Product/Process Change Notification 2018-12-3

NV6115, NV6117

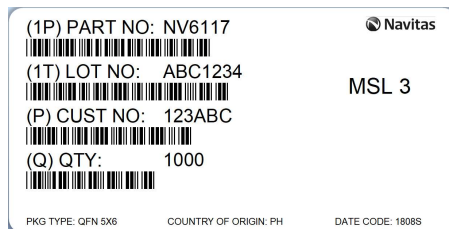
The NV6115 and NV6117 Moisture Sensitivity Level (MSL) have been upgraded from MSL3 to MSL1.

NV6115 and NV6117 have met MSL1 criteria since production release, however, the MSL3 rating was used until additional production lot validation testing could be completed.

Based on gathering package reliability data from production lots over the first 6 months of production the parts will now be processed and labelled as MSL1.

There are no changes to component materials or processing methods as part of this change.

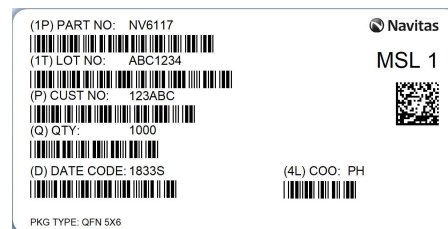
The packaging labels have changed to reflect MSL1 status as below:

FROM

TO
